Service Bulletin

Bulletin No.: 15-NA-043

Subject: Rear Turn Signal Inoperative and/or Turn Indicator Failure Message Displayed in DIC

Brand:	Model:	Model Year:		VIN:		Engine:	Transmission:
		from	to	from	to		
Cadillac	SRX	2015	2015	March 1, 2015	April 30, 2015	All	All

4291162

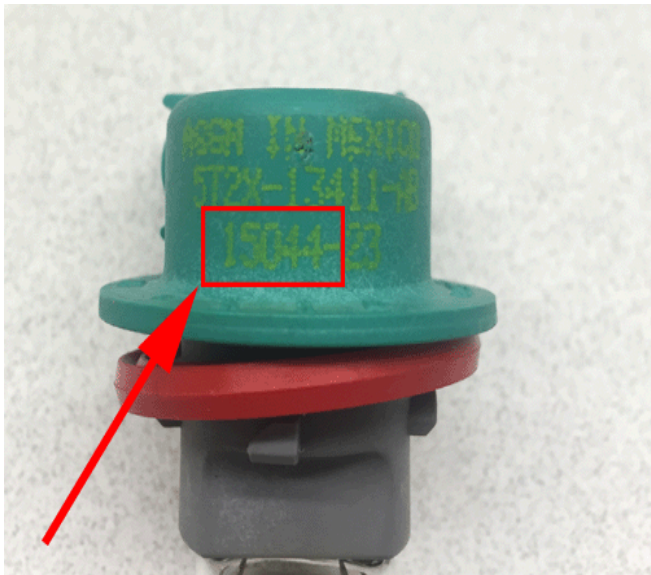
Condition	Some customers may comment on a rear turn signal inoperative and/or a turn indicator failure message displayed on the DIC.
Cause	This may be caused by an internal failure within the rear turn signal socket.

2. With the rear turn signal bulb socket removed, visually inspect the socket julian date on the back of the socket as illustrated above.
 - If the julian date is within 15032–15120, replace the affected socket.
 - If the julian date does not fall in between 15032–15120, continue normal diagnosis referring to SI.

1. Remove the affected turn signal socket from the tail lamp. Refer to Rear Turn Signal Bulb Replacement in SI.

Description	Part Number
SOCKET ASM-RR T/SIG LP	25984639
